PPB Response to Utility Regulator Consultation Paper on Rate of Change of Frequency Modification to Grid Code

September 2013

Figure 1 Straight Line Grid Code Test

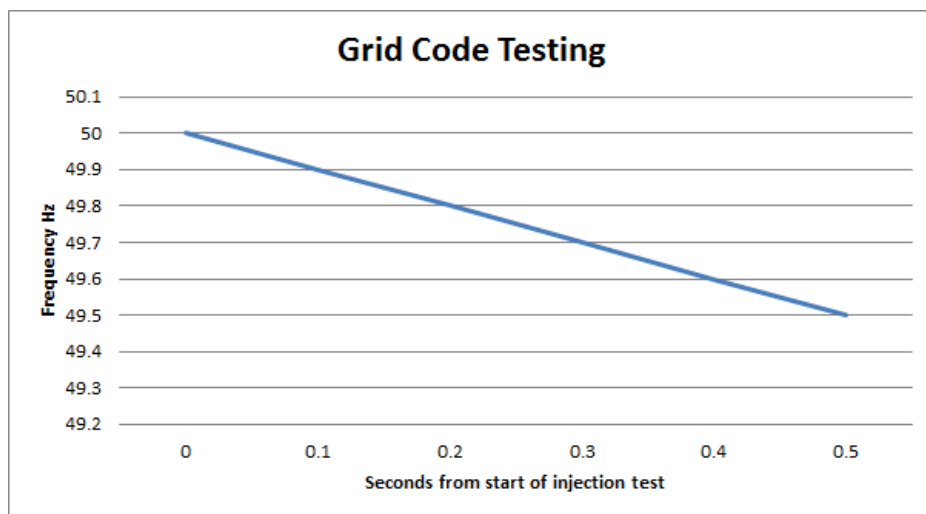
It is important that before the Utility Regulator directs a Grid Code modification that the standard is defined more appropriately. The 1Hz/s measured over 500ms is appropriate for a protection relay setting, which is what is being discussed in GB, however the SONI standard is different in its application. Within the 500ms window changes of frequency far in excess of 1Hz/s could be realised and what is required should be defined within the standard. This is best illustrated by considering how one would test the new standard. For example, the test could be either a straight line as illustrated in Figure (1) or it could be a dynamic waveform as illustrated in Figure (2). If this is not defined then it is likely to be disputed between the TSO and the Generator.
